## Evaluation of Proposed Testing and Monitoring Activities at Carbon TerraVault's Monterey Formation A1-A2 Class VI Project

This testing and monitoring evaluation report for the proposed Carbon TerraVault (CTV)-Elk Hills Class VI geologic sequestration (GS) project summarizes EPA's review of the testing and monitoring the applicant proposes to conduct during and following injection operations into the Monterey Formation A1-A2 Sands. Due to the similarities of certain monitoring activities (e.g., groundwater monitoring and plume and pressure front tracking) to be performed in the injection and post-injection phases, these activities (as described in Attachments C and E of the Class VI permit application dated August 30, 2021, and Attachment E with information specific to well 355-7R submitted on December 3, 2021) are evaluated in a single report. This review identifies preliminary questions for the applicant, includes requests for supplemental information, and provides some considerations for future testing/analytical requirements. Note that, because of the interdependencies between the testing and monitoring strategy and other aspects of the permit application, additional questio

Figure 2 of the QASP shows the locations of all monitoring wells associated with the project and is reproduced below.

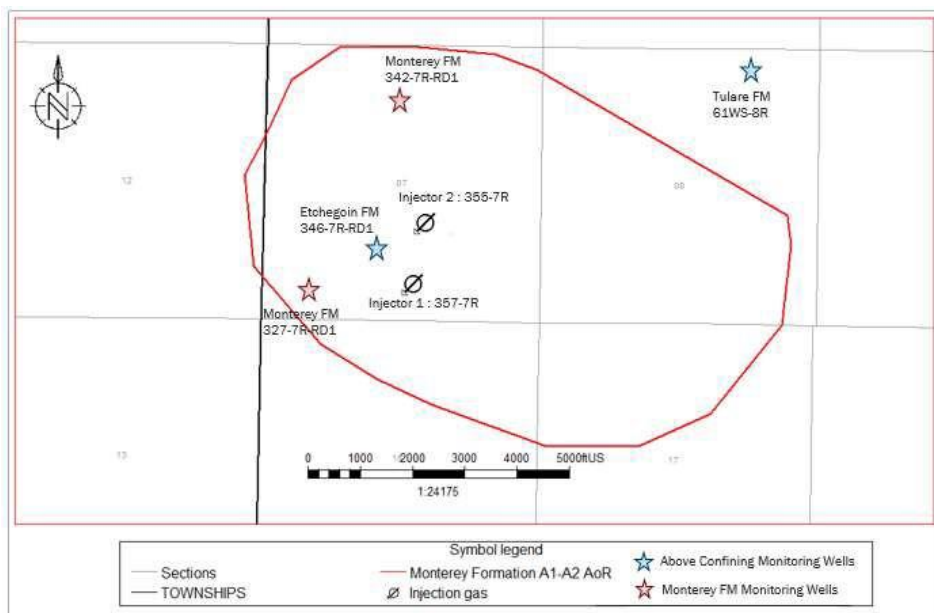
The Etchegoin Formation monitoring well appears to be situated within the AoR and in the anticipated path of the CO<sub>2</sub> plume and pressure front (based on information in Attachment B). The Upper/Lower Tulare Formation monitoring well is outside of the delineated AoR to the northeast of the injection wells, and down plume. Given that the Tulare Formation does not hold much water within the AoR, this location, while not in the same direction as the deeper monitoring wells may be most appropriate to allow geochemical sampling, although it is unlikely that CO<sub>2</sub> will travel that far down the limb of the anticline. CTV states that additional Upper Tulare monitoring wells will be drilled if increased pressure is observed in the Etchegoin Formation monitoring well or water quality changes in the Tulare Formation that is due to Monterey Formation A1-A2 CO<sub>2</sub> injection. However, it is unclear how a linkage of water quality/pressure changes to CO<sub>2</sub> injection (and not other activities) would be made.

- *Please explain the appropriateness of a single Tulare Formation monitoring well location relative to the anticipated direction of plume and pressure front movement, and, given the size of the injection operation. Additionally, please confirm that the predominant groundwater flow direction in the Tulare Formation is easterly. If flow direction is not easterly, provide an updated groundwater well monitoring plan that includes appropriate well placement in relation to groundwater flow direction.*

- *Please include the groundwater monitoring well 61WS-8R in Figure 4 of the PISC and Site Closure Plan.*
- *Is Zalco laboratory a state-certified laboratory? Please note that EPA's Class VI UIC guidance recommends use of a laboratory that is state-certified.*
